SERVICE BULLETIN

LATCH CAN BREAK ON AVOX SYSTEMS P/N 36758-12 PORTABLE CYLINDER BRACKET ASSEMBLY FOR MOUNTING PORTABLE CYLINDER ASSEMBLIES (PCAs)

AVOX Systems P/N 36758-12 Bracket Assembly
Figure 1

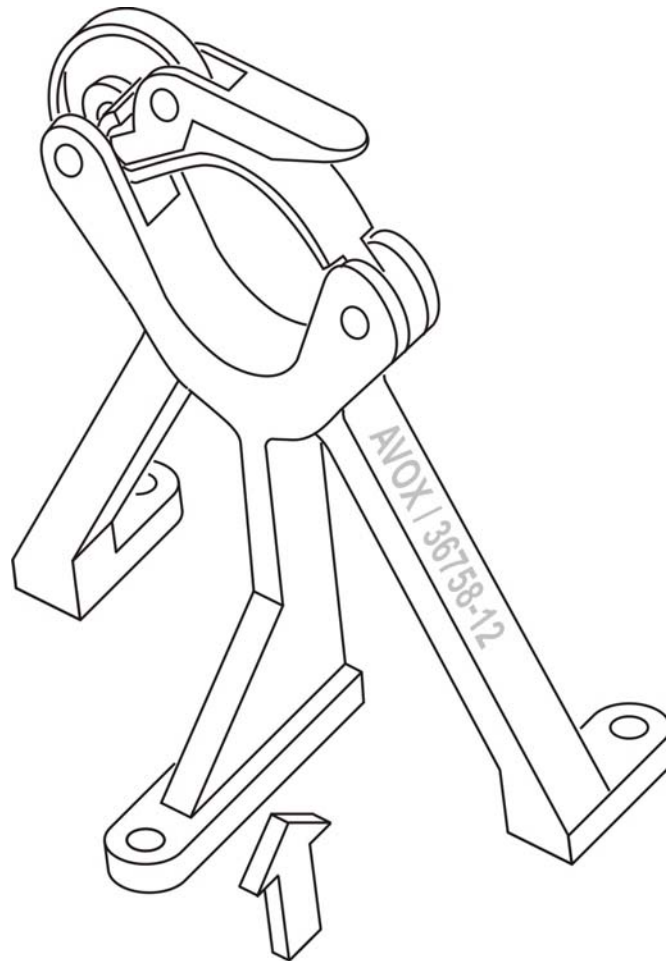
C. Inspect all brackets on board all aircraft and in stores to determine if any brackets are affected. The P/N to look for is "AVOX / 36758-12" on an outside leg of the bracket as shown in Figure 1.

NOTE: Brackets with the marking "SCOTT / 36758-12" are exempt from this SB.

NOTE: Brackets that look similar to the bracket in Figure 1 but that do not have the "AVOX / 36758-12" mark are exempt from this SB.

- D. All brackets with “AVOX / P/N 36758-12” on the attaching leg must be removed, if installed on an aircraft, in accordance with the Aircraft Maintenance Manual (AMM) and the lot number must be determined by inspecting the bottom of the center leg as shown in Figure 2.
- E. Remove from service all brackets with the Lot Number 33155 or Lot Number 35916 on the bottom of the middle mounting leg and return to AVOX Systems (see 4. Appendix for contact information). Otherwise reinstall unaffected brackets in accordance with the AMM or return to stores as appropriate.
- F. Where required, replacement brackets will be provided by AVOX Systems Free of Charge (FOC). Please complete the form on page 7 and submit it with the faulty bracket(s) to the address on the form.
